PUBLIC HEARING: Consider Preliminary Plat Approval and Zoning Amendment for COR THREE (North Commons) Located North of Bunker Lake Boulevard and West of Armstrong Boulevard; Case of the City of Ramsey Housing and Redevelopment Authority (HRA)

**Re: Preliminary Plat (Major Plat) and Site Plan Review  
COR THREE**

**CITY OF RAMSEY PLANNING DIVISION  
REVIEW FILE**

We are in receipt of your preliminary plat and site plan to develop a plat within The COR for seventeen (17) single-family homes and an outlot for future park development (North Commons). The submittal consists of five (5) sheets prepared by Landform Professional Services, dated June 6, 2012. We offer the following comments:

CIVIL TITLE SHEET  
**C0.1**  
SHEET NO. /

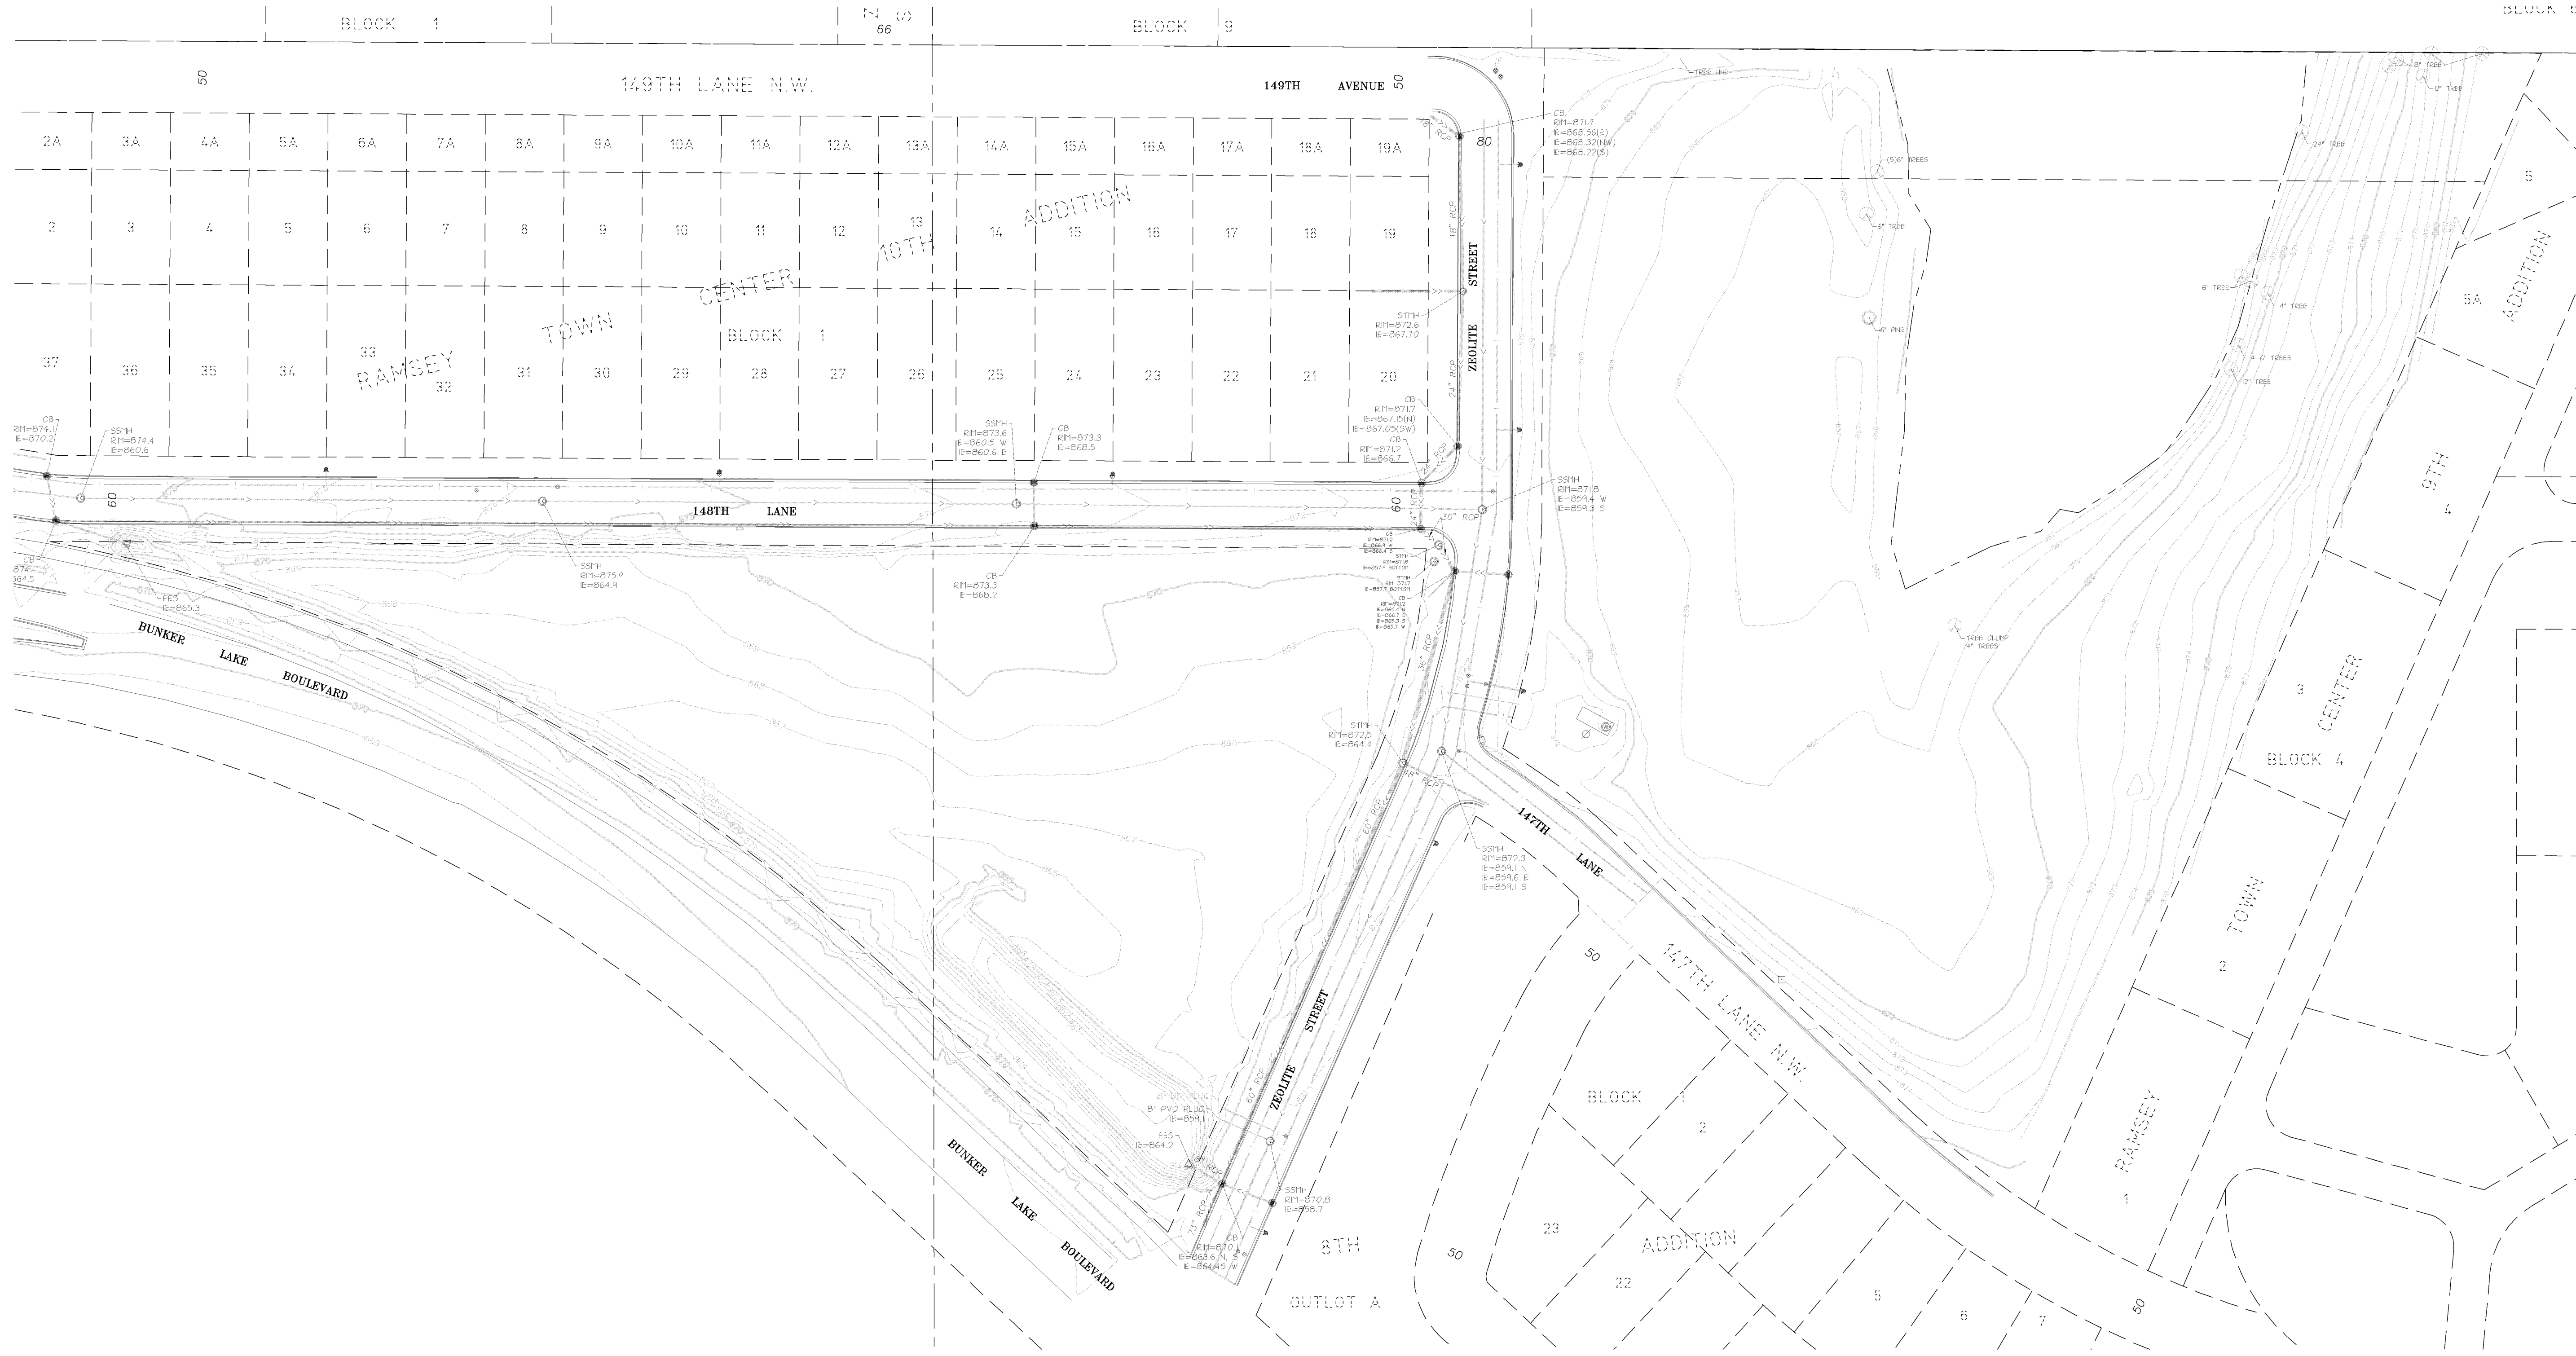
- Benchmarks are shown on the cover sheet. They are located south of Sunwood Drive. Benchmarks north of Bunker Lake Boulevard must be provided.
- Grading limits must be shown on the plans. The topsoil test plots and community garden locations must also be shown.

PRELIMINARY PLAT

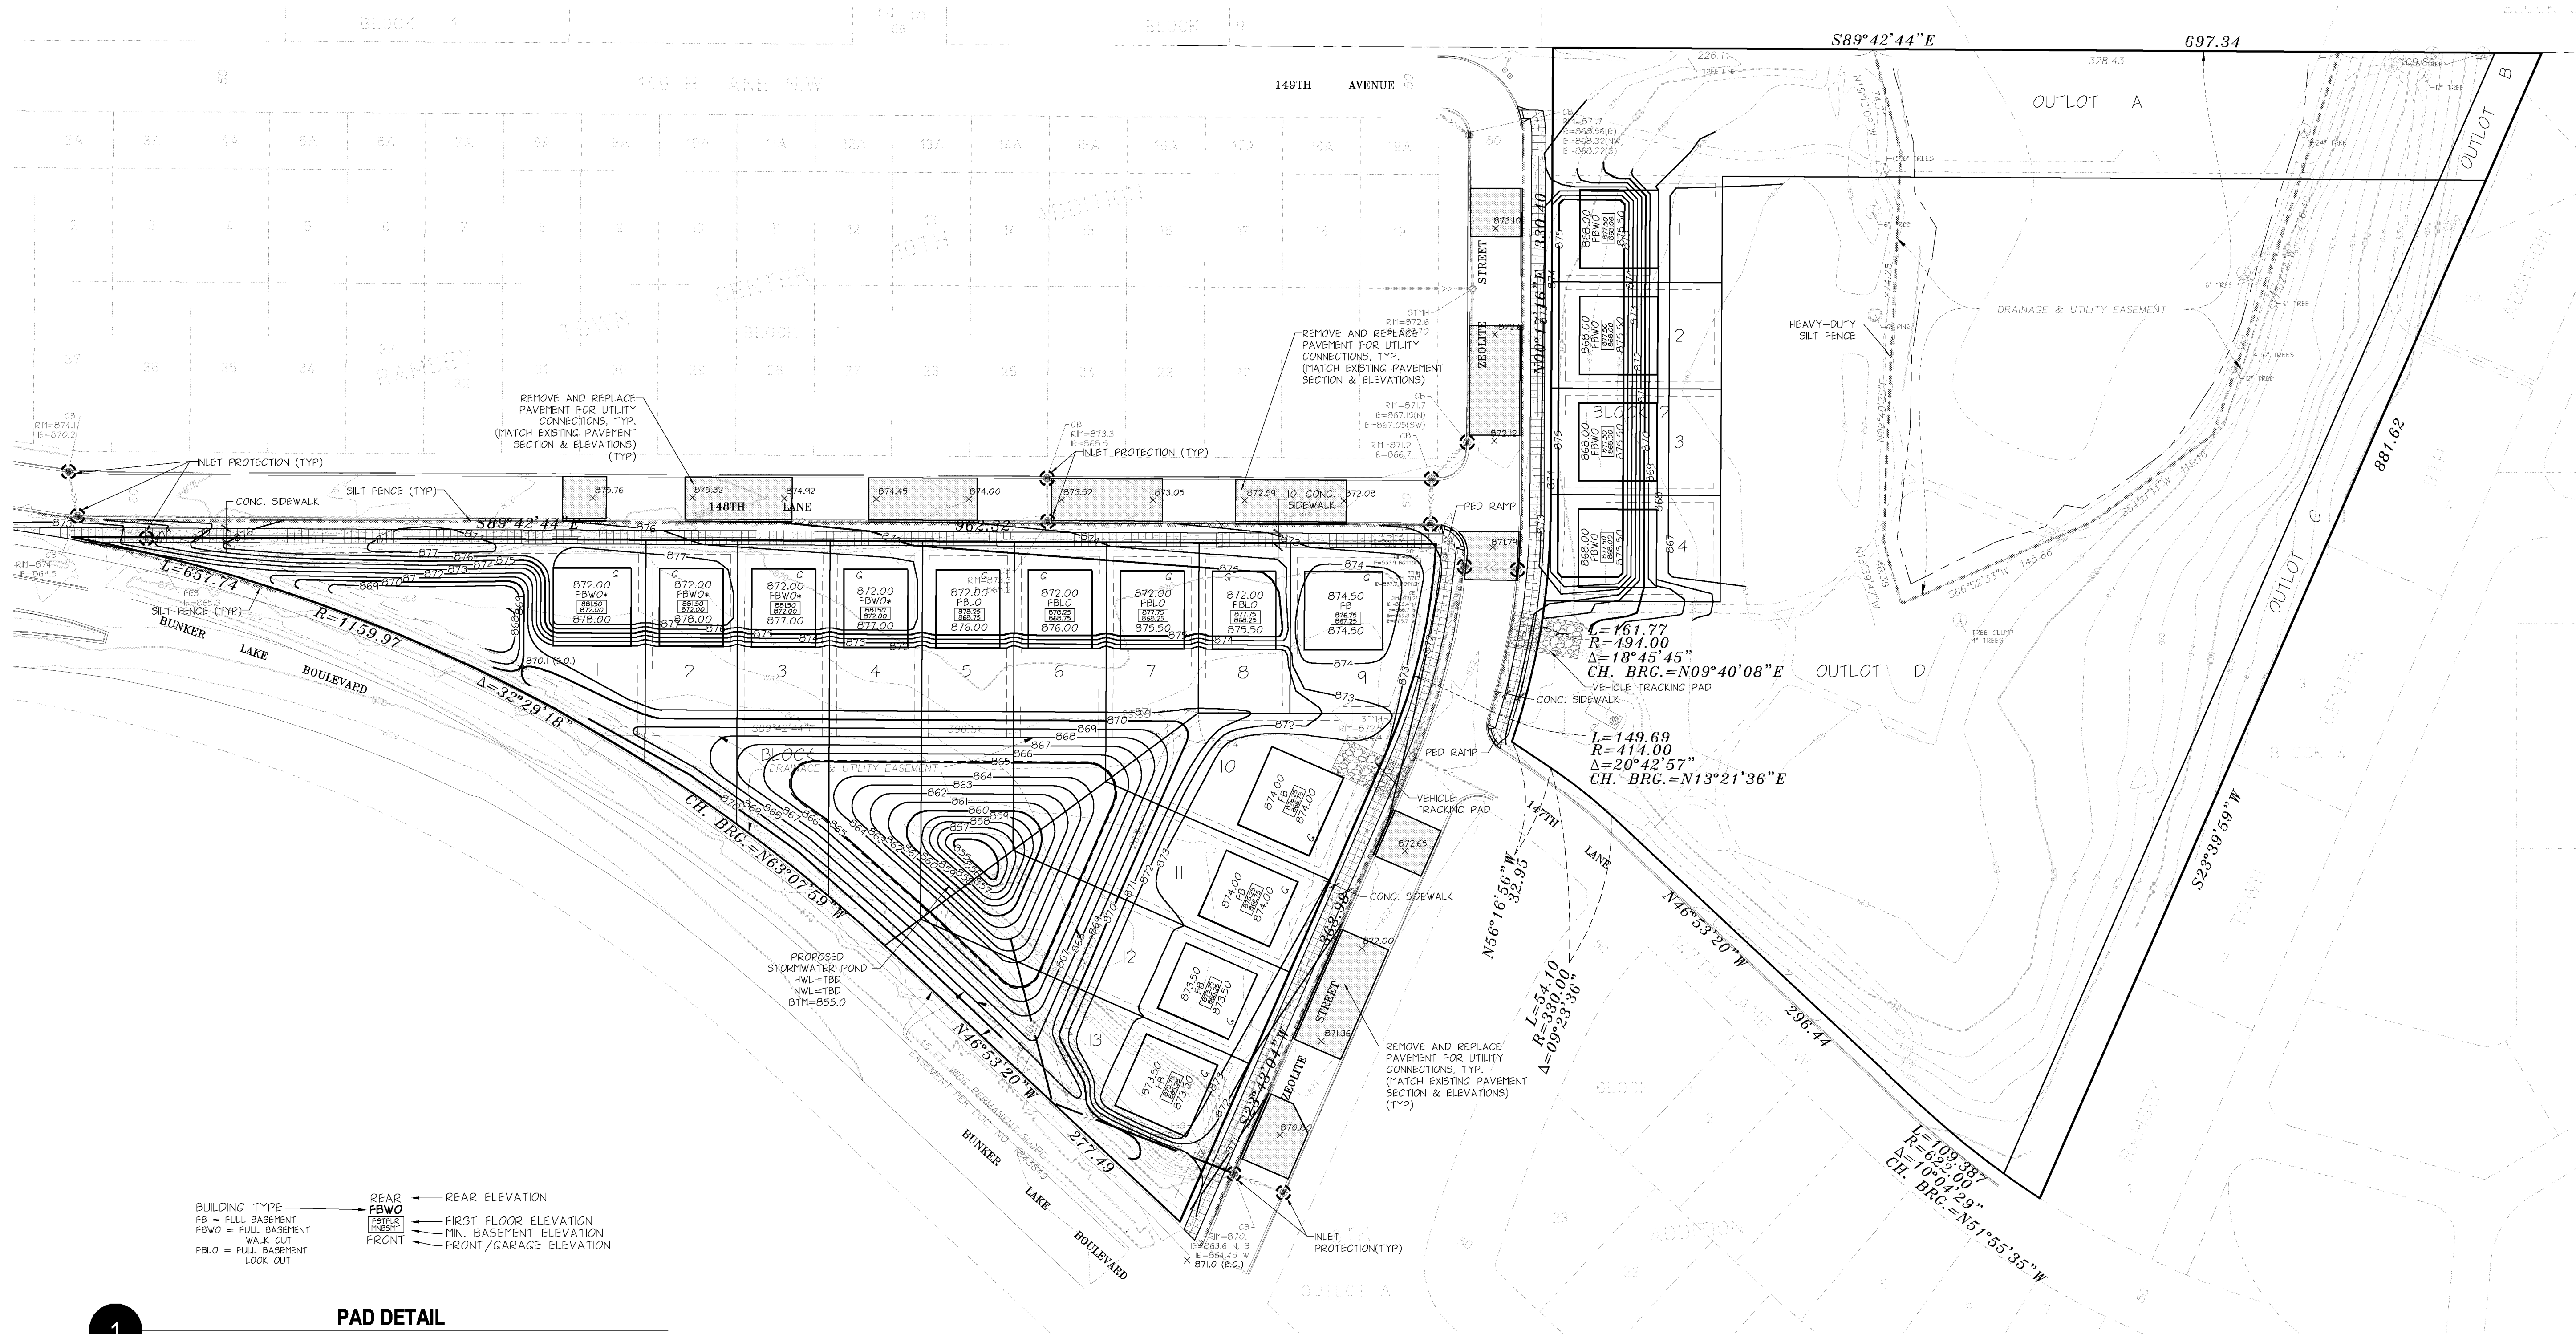
All proposed lots appear to meet these requirements. The City is awaiting a response in regards to Lot 13, Block 1 from Anoka County to ensure adequate spacing of the structure.

Staff would like to further explore Lot 1, Block 1 in terms of Stormwater management, required easements, and boulevard tree requirements as noted below. Perhaps the westerly extension of this parcel should be encumbered by a drainage and utility easement.

**GRADING, DRAINAGE, PAVING & EROSION CONTROL**  
**C3.1**  
 SHEET NO. /

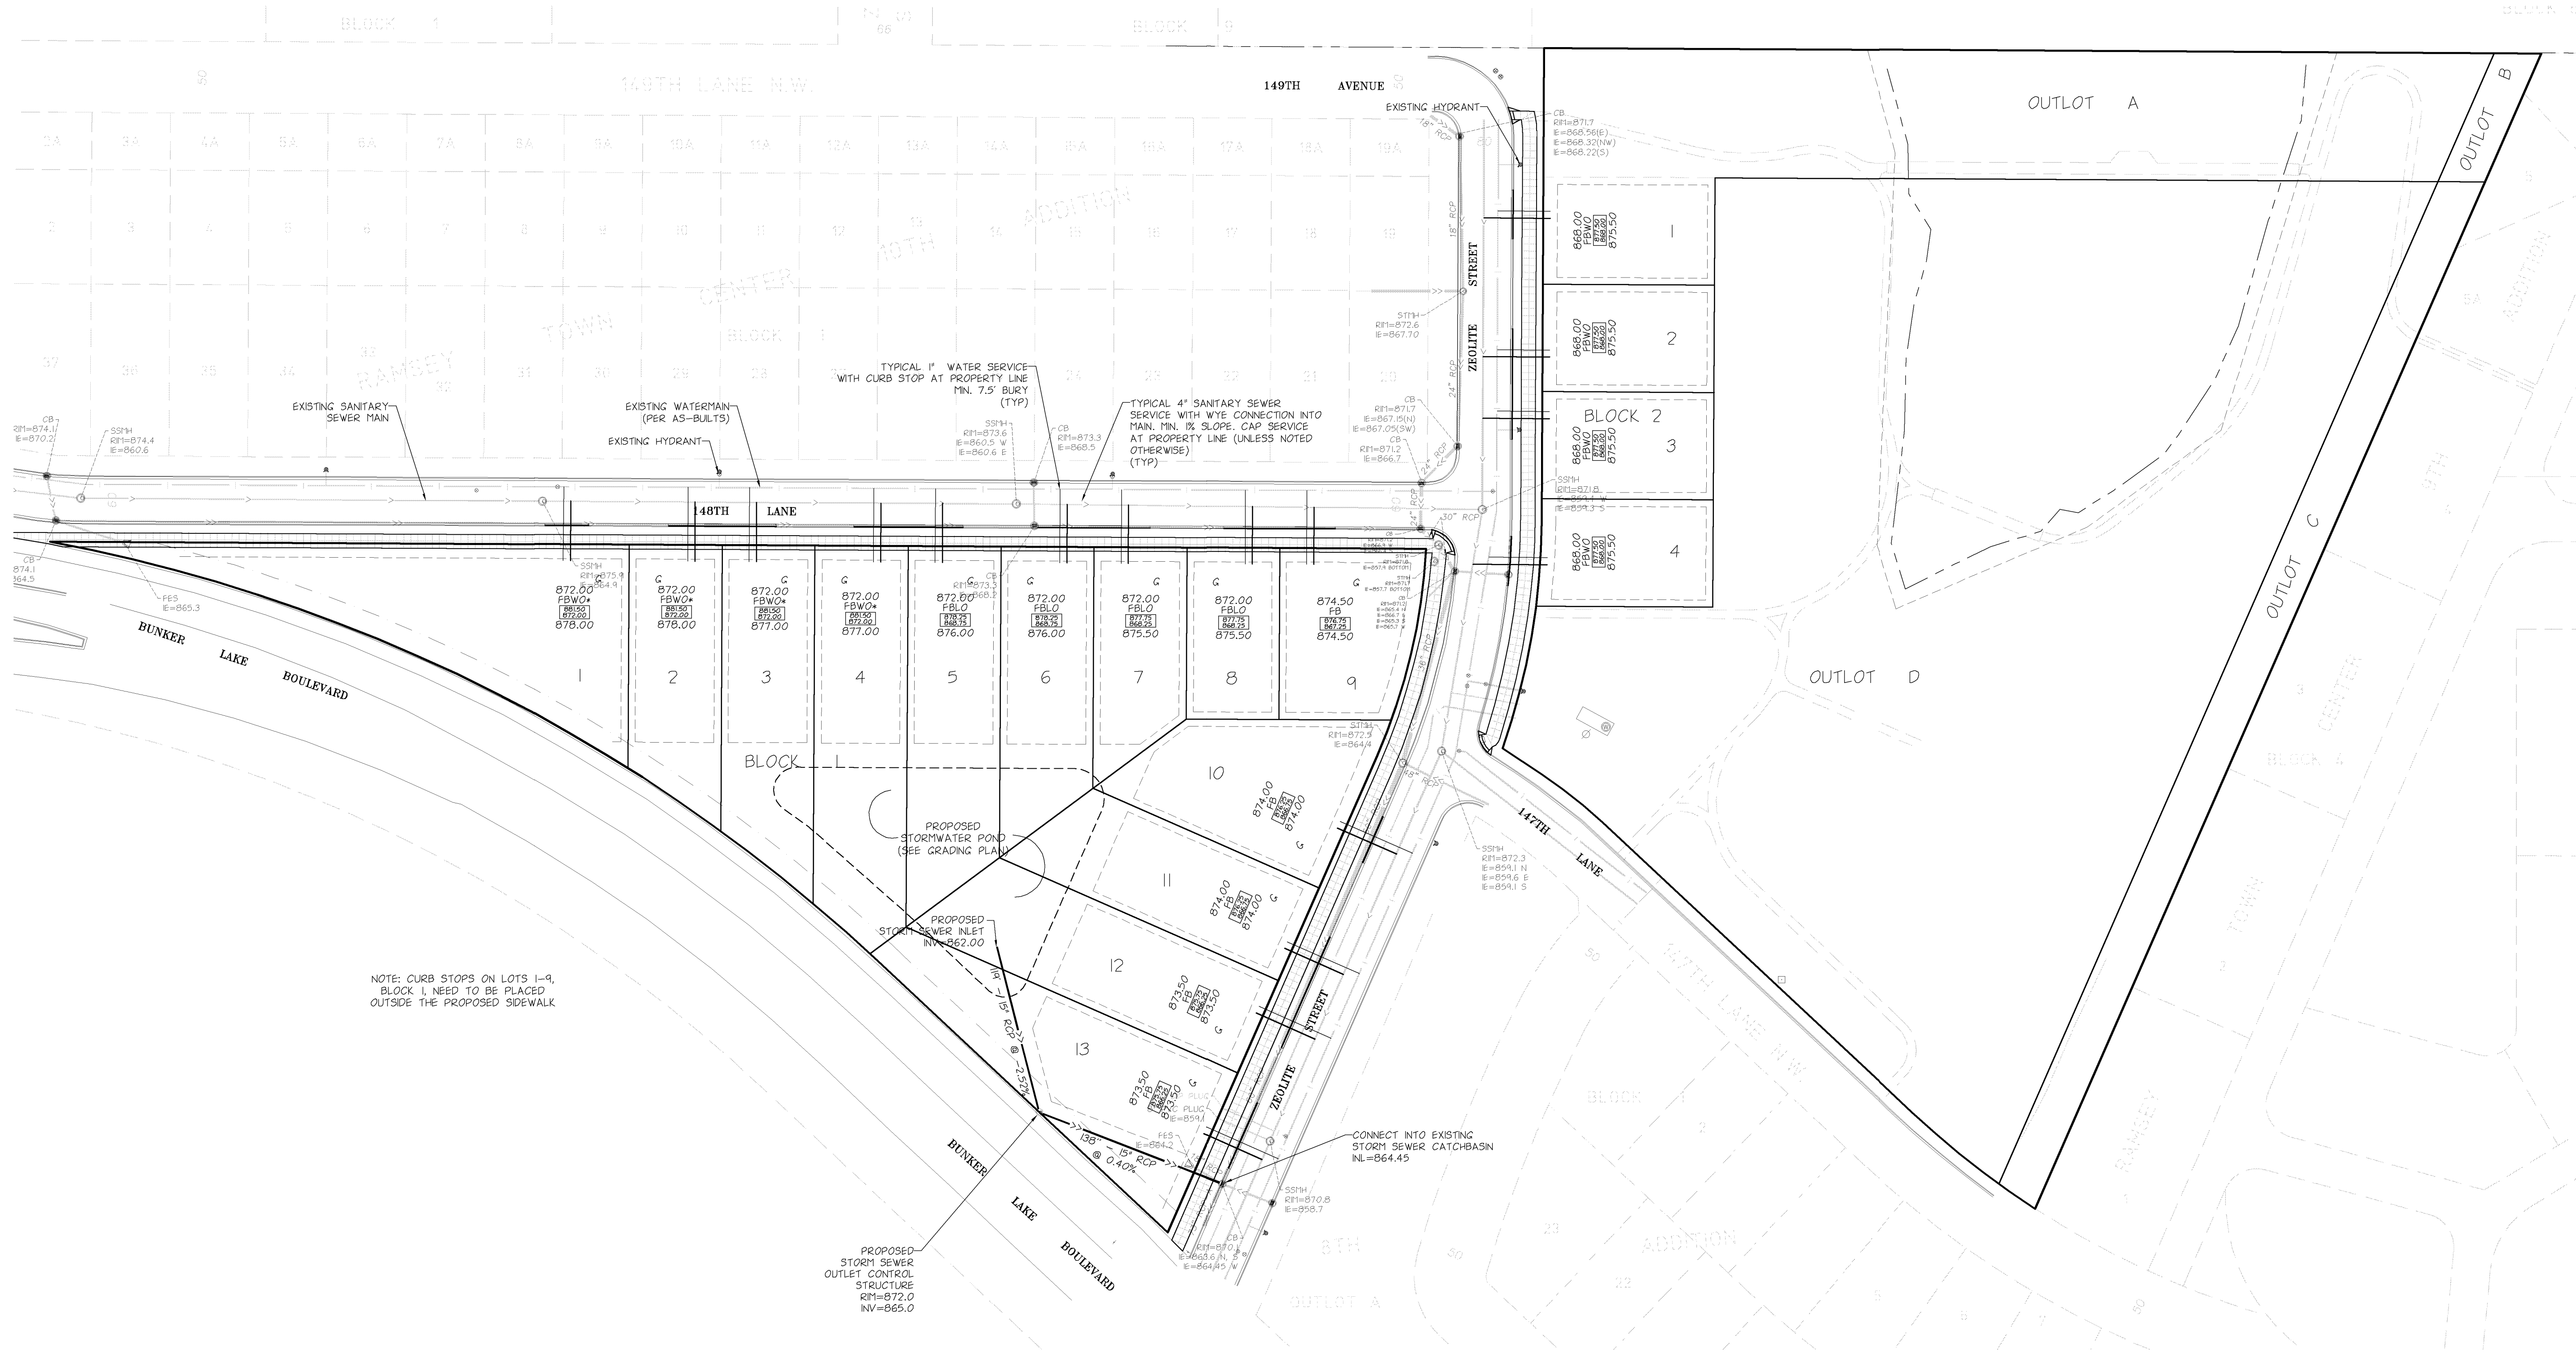
- The plans call for scraping the streets at the end of each day. This shall be replaced with sweeping the streets, scraping the soil off the street is not an acceptable Best Management Practice in the City.

- The walkout elevations and garage floor elevations should be adjusted so that the garage elevation is adjacent to the garage.
- The NPDES summary on the grading page does not reflect the proposed impervious cover on the site.

- We estimate the proposed impervious cover is close to 1 acre, not 0.07 acres.
- The normal and high water elevations of the pond must be shown on the plans.

- The lowest opening elevations for Lots 1 – 4, Block 2 must be re-evaluated as noted in the Stormwater Analysis section.
- Please provide the proposed function of the low area on the west part of Lot 1, Block 1. It appears to be a small ponding area; however, it is not protected with drainage and utility easements.
